Chippenham Cycle Network Development Group (Cycle Chippenham) response to PL/2026/02190 ATS Euromaster, Cocklebury Road CHIPPENHAM, SN15 3QF

Proposal: Change of Use from Tyre Fitters (B1 use) to Convenience Shop (class E)

Cycle Chippenham response

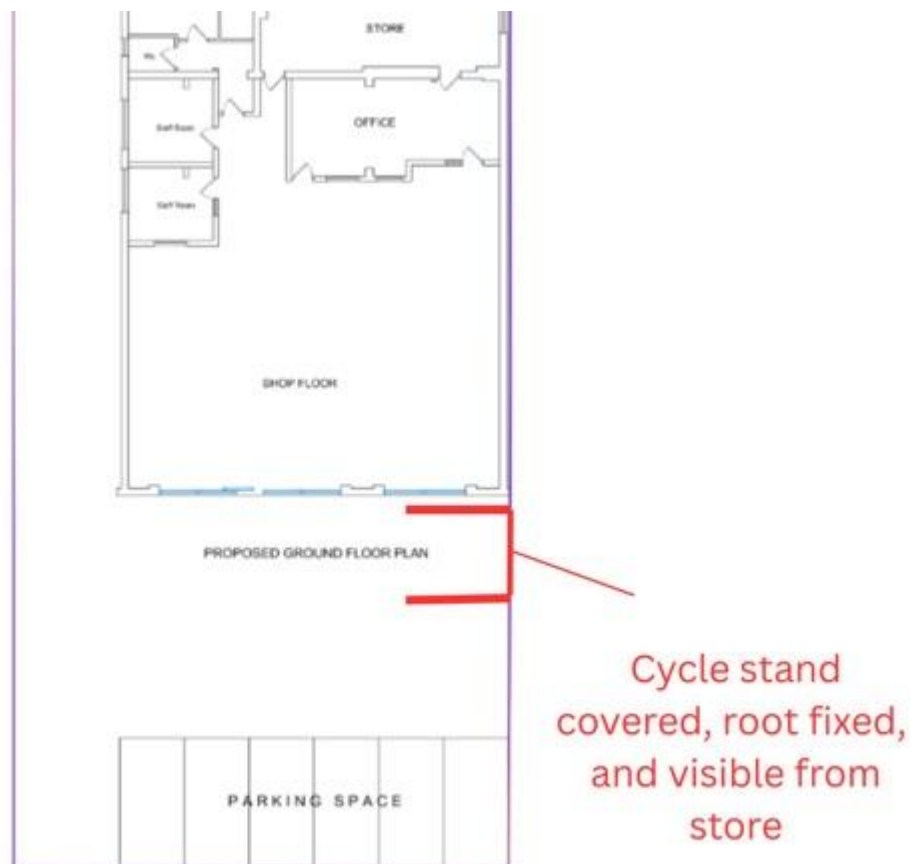
The Design and Access statement describes the 'potential to create **bicycle storage**'. The Town Centre Impact statement acknowledges the site is accessible by 'foot, **cycle**, and car'; yet no cycle parking appears to be proposed.

Cycle parking is required, in line with the numbers set out in LTN 1/20 table 11-1. This should be immediately outside the main front entrance to the Convenience store, as indicated in the photo and diagram below.

It is critical for a facility such as this that cargo cycles and cycles with trailers are accommodated in the cycle parking (up to 2.8m long and up to 1.2m wide, as per the Cycle Design Vehicle specified in LTN 1/20).

- Covered;
- Near the store entrance;
- Use root fixed stands;
- Capable of accommodating cycle design vehicle in LTN 1/20;
- Designed so it can't be blocked by parked vehicles, e.g. with a hatched area in front. The [cycle parking at Cinch self-storage](#) is an example of good practice that we would recommend following.

It is suggested that the entrance to the cycle parking area be parallel to the store front, such that cycles parked inside of the stand are visible from inside the store, for additional security. Visibility from inside the store is likely to instil staff and visitors with greater confidence that their cycles can be safely locked and left, encouraging cycling to work and cycle journeys to the store.
